CITY OF ALBUQUERQUE

**RE: Coors Pavilion Subdivision Lot 4 & Portion of Lot 5
9154 Coors Blvd
Grading Plan
Engineer's Stamp Date: 3/1/2017
Hydrology File: G11D069B**

CITY OF ALBUQUERQUE
PUBLIC WORKS DEPARTMENT
ENGINEERING DEVELOPMENT GROUP
COORS PAVILION SUBDIVISION
LOT 4 & PORTION LOT 5
GRADING & DRAINAGE PLAN

C-101

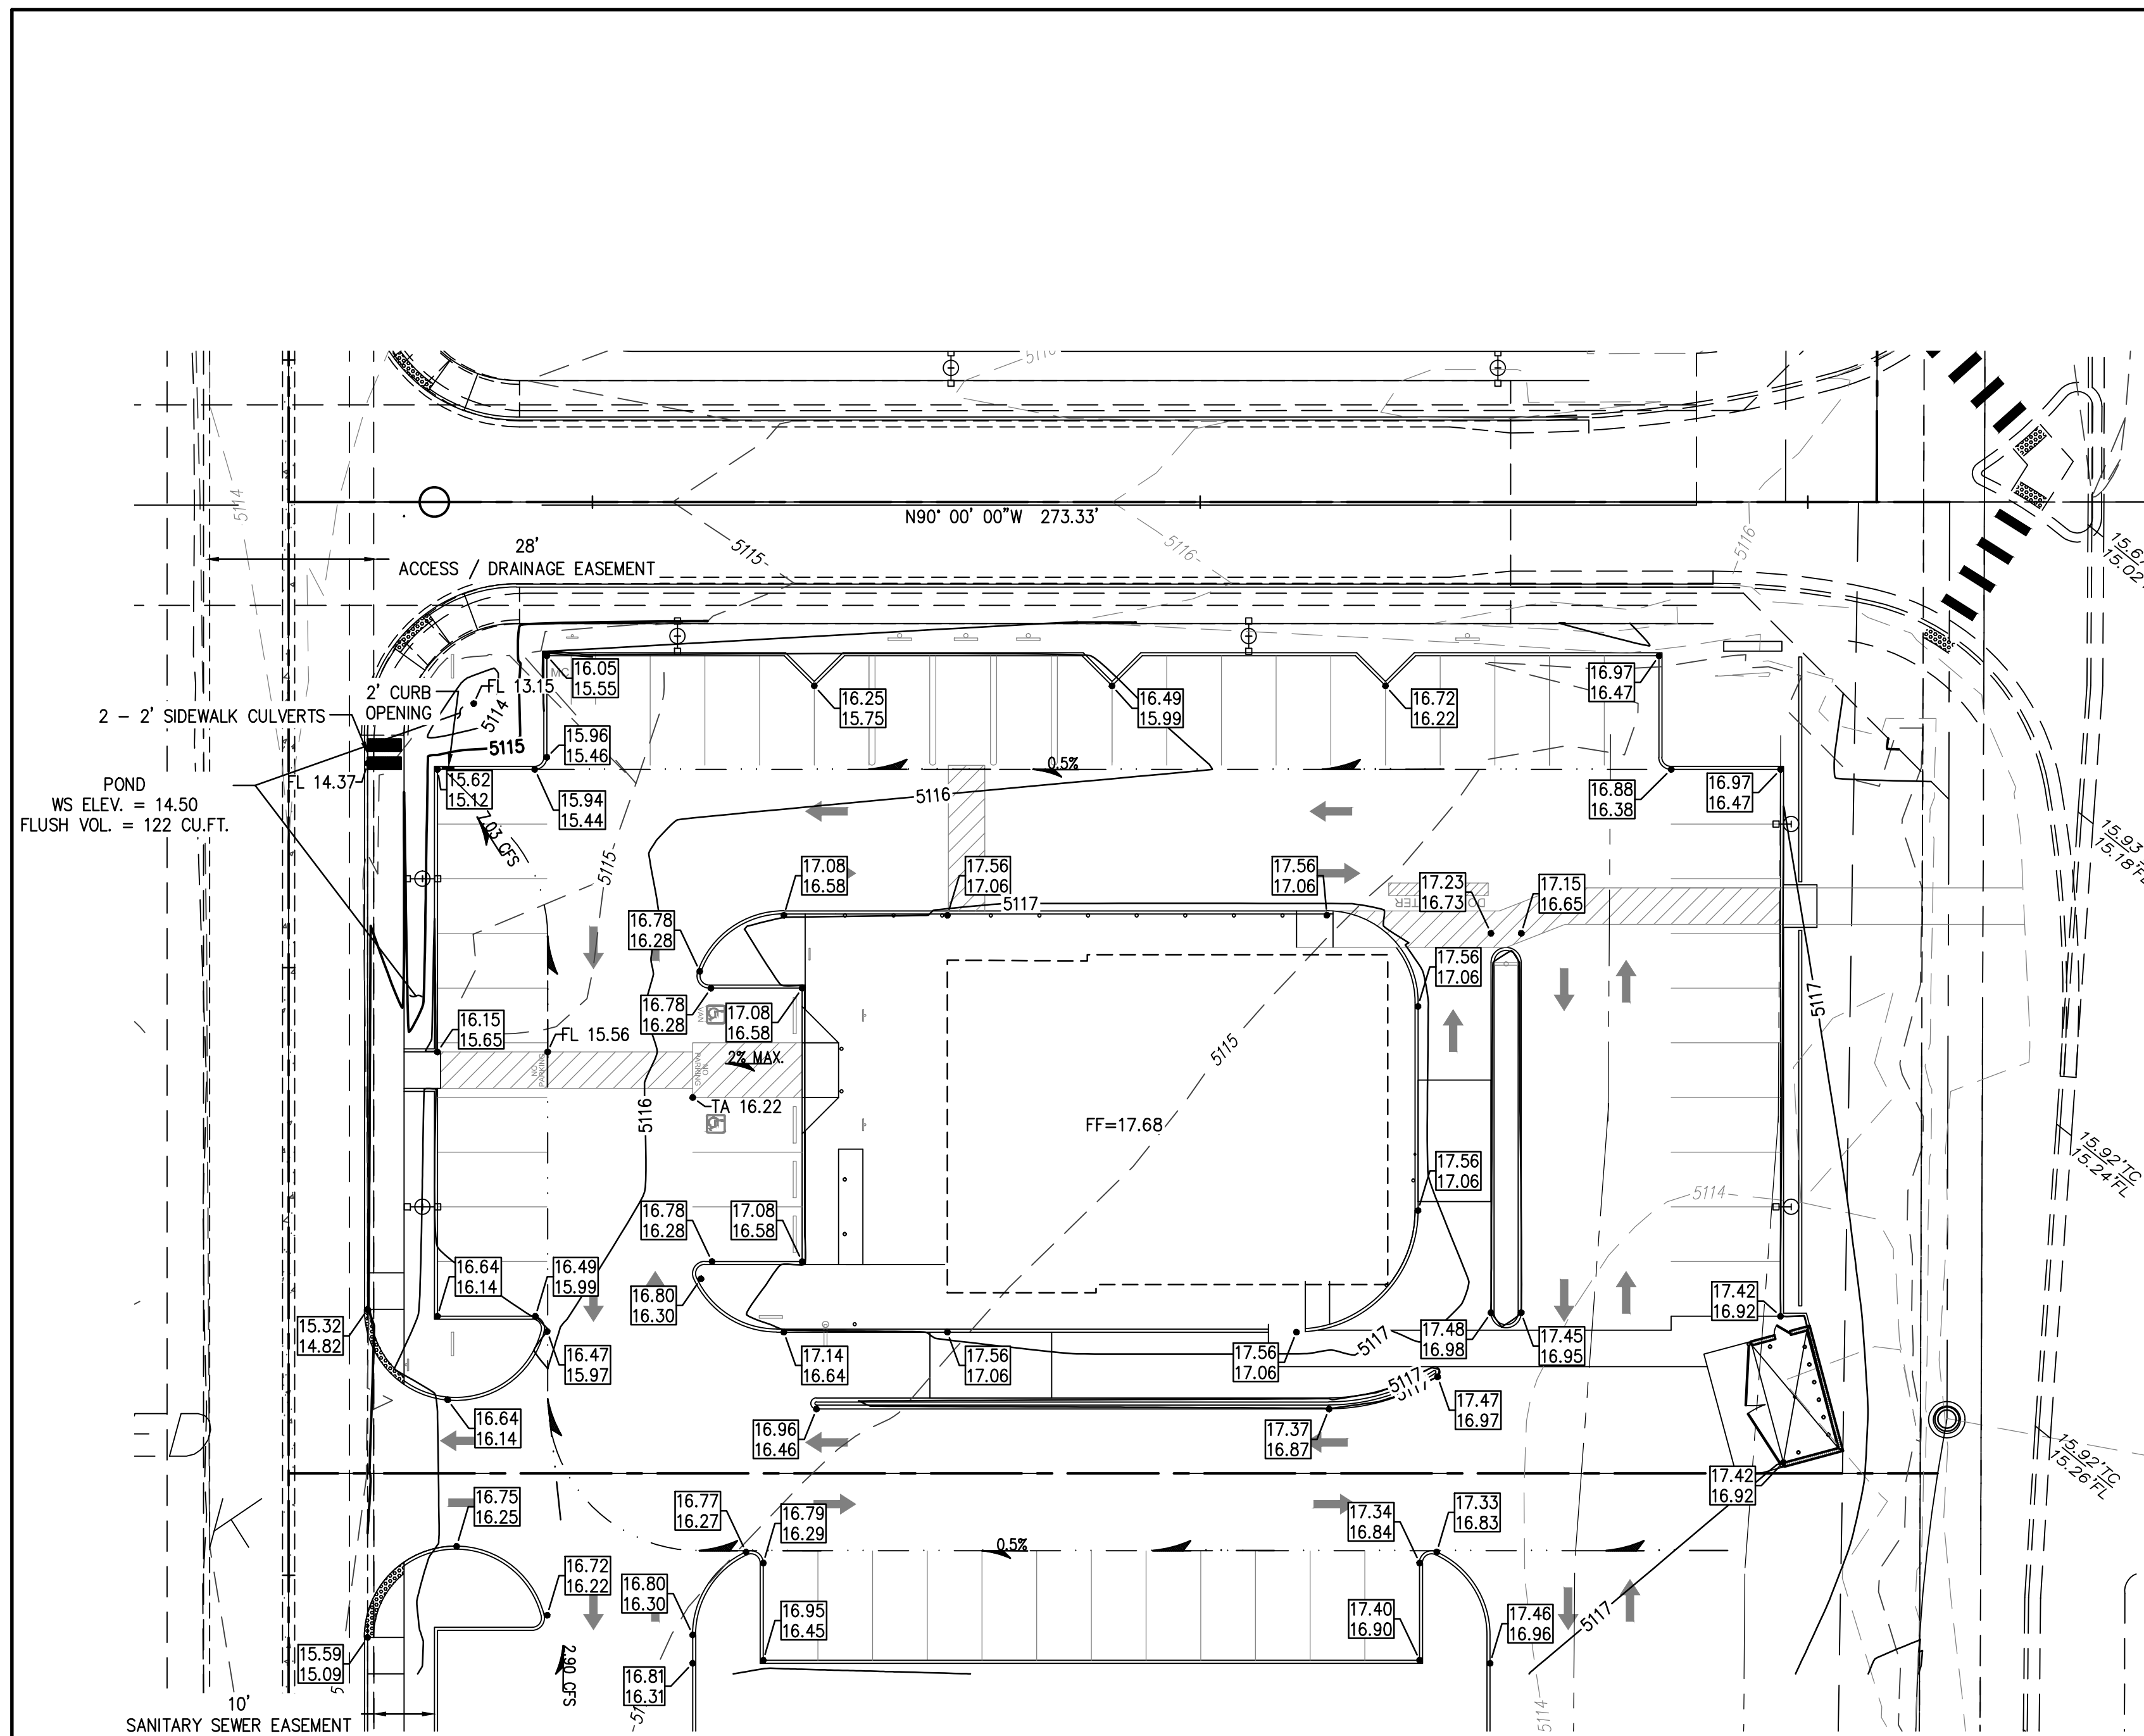
1. Prior to Final Plat, a cross-lot drainage easement will be required for Lot 4 for the benefit of Lot 5.
2. Are either of these lots being developed as restaurants? If so, provide trash enclosure containment and drainage through a grease trap and into the sanitary sewer.
